URBAN DESIGN CONSULTATION RESPONSE

Design Officer	Azhar Kapadi
Date	10.10.25
Application Reference	25/00510/FUL
Address	Ginnell Farm, Broad Lane, Rochdale, OL16 4PU
Proposal	Demolition of existing buildings and the erection of 9 no. dwellings, including associated landscaping and access

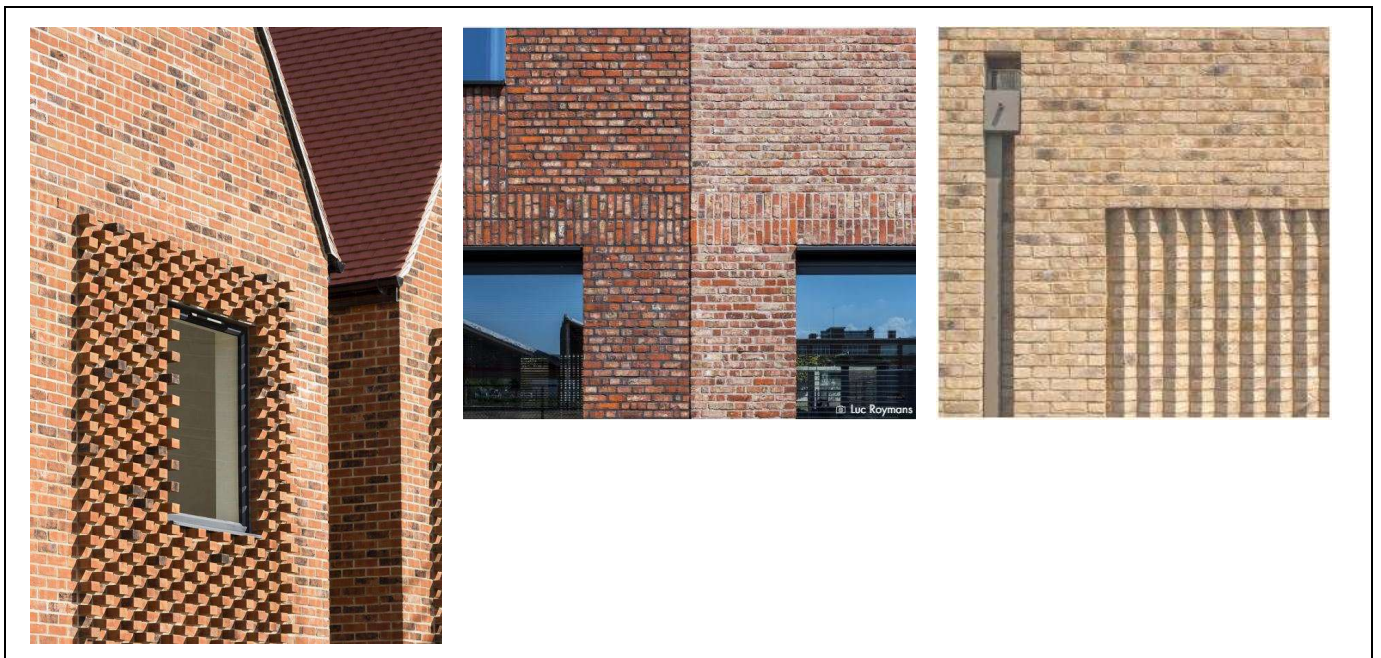
The proposed strategy to screen unsightly boundary treatments with trees and native landscaping is supported and should be implemented across the site. Specify locally appropriate species and planting densities capable of effectively screening fencing within a reasonable establishment period, and secure long-term management through a landscape management plan.

The two visitor parking spaces in the location shown must be reassessed; their current position produces a weak outlook and poor street frontage for residents and constitutes poor urban design. Reconfigure the plot layouts to allow a turning head within the access road, which remains feasible and would materially improve circulation and street character.

The gap between Plot 7 and Plot 8 is excessive, car dominated and overly tarmacked. Redesign this gap to reduce vehicle dominance, introduce softer surfacing and planting, and remove opportunities for tandem parking that could obstruct the turning head.

Provide a coherent street elevation for Plots 4–9 that includes the highway alignment and the adjacent development. This elevation should demonstrate how the proposed frontage treatment and building lines read in context and confirm the effectiveness of the proposed screening.

Where trees are located within private curtilages they can improve frontage but present long-term management risks. Require a management and maintenance strategy secured by condition that sets out

responsibility, maintenance standards and replacement provisions. Consider using planning controls to restrict permitted development rights where necessary to safeguard planting and frontage treatments.

Further landscaping detail is required for the parcel of land beside the existing footpath running north to south. Something more interesting can be done to improve this.
